BODY—TOP SURFACE OF REAR CARGO DOORS SCRATCHED	Article No. 01-24-7

FORD: 2002 EXCURSION

Figure 1 - Article 01-24-7

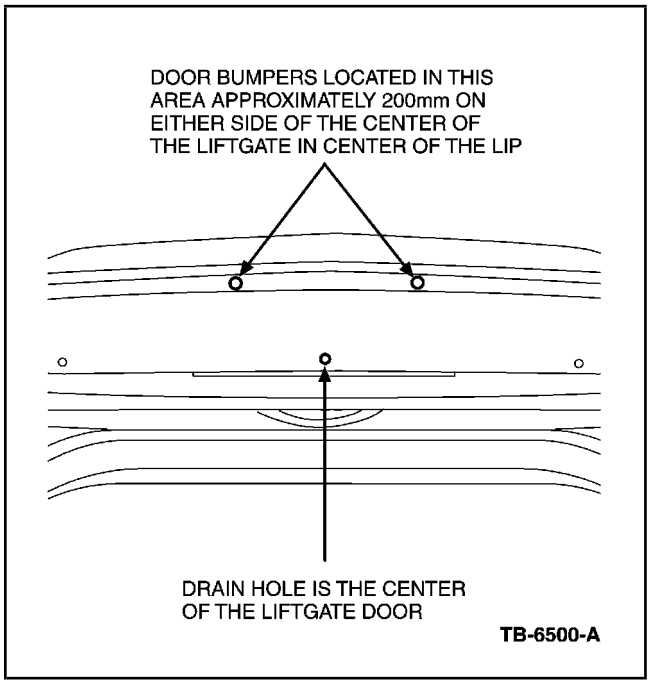
Some vehicles may exhibit scratching of the top of the cargo doors by the bottom of the liftgate and the applique attached to the liftgate. This may be caused by the cargo door "jumping" when the liftgate is slammed closed or driving over rough roads.

Drill two (2) 5 mm diameter holes into the liftgate 200 mm on both sides of the center of the liftgate in the center of the outer door lip (Figures 1 and 2). Install Door Bumpers part number N805307-S in the two holes using a small blade tip screwdriver.
